GNRO-2011/00076

SUBJECT: License Amendment Request  
Criticality Safety Analysis and Technical Specification 4.3.1, *Criticality*  
Grand Gulf Nuclear Station, Unit 1  
Docket No. 50-416  
License No. NPF-29

**Analysis of Proposed Operating License and Technical Specification Changes**

**Proposed Operating License and Technical Specification Changes (Mark-up)**

Figure 4.3-1  
Region II 4X4 Storage Configuration

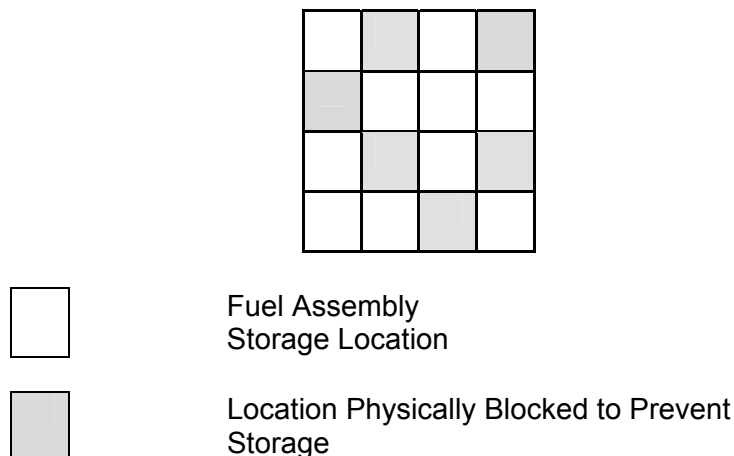
2. Storage cells face-adjacent to Region II panels are either restricted from fuel storage by physically blocking the isolated cells or are configured to meet, as a minimum (i.e., additional cells may be blocked), the Region II fuel storage configuration requirements in Figure 4.3-1.
3. When a 4x4 array of cells is classified as Region II and face-adjacent to another Region II 4x4 storage array, the new Region II 4x 4 array is required to be blocked in the same 6 of 16 pattern and at the same orientation as the adjacent Region II 4x4 storage configuration.

The proposed figure establishes the requirement that at least 6 of 16 Region II fuel assembly storage locations are physically blocked in the designated configuration. Since the Boraflex in Region II is not credited, additional locations within the 4 x 4 Region II storage array may be conservatively blocked without compromising the minimum 6 x 16 configuration. The orientation of any adjacent Region II 4x4 array is required to be consistent with the existing Region II 4x4 array. Cells face-adjacent to isolated panels that meet the Region II threshold are physically blocked from storing any fuel assemblies. The Region II storage configurations designated in the Technical Specifications are consistent with the Spent Fuel Pool Criticality Safety Analysis.

Figure 4.3-1  
Region II 4X4 Storage Configuration

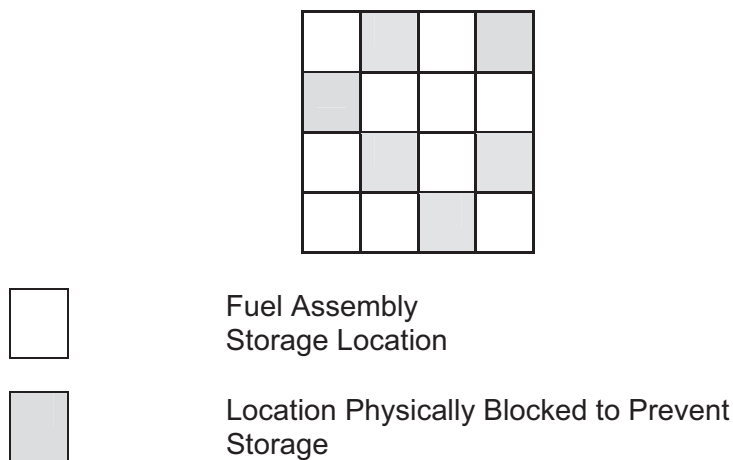
- 2. Storage cells face-adjacent to Region II panels are either restricted from fuel storage by physically blocking the isolated cells or are configured to meet, as a minimum (i.e., additional cells may be blocked), the Region II fuel storage configuration requirements in Figure 4.3-1.

- 3. When a 4x4 array of cells is classified as Region II and face-adjacent to another Region II 4x4 storage array, the new Region II 4x 4 array is required to be blocked in the same 6 of 16 pattern and at the same orientation as the adjacent Region II 4x4 storage configuration.
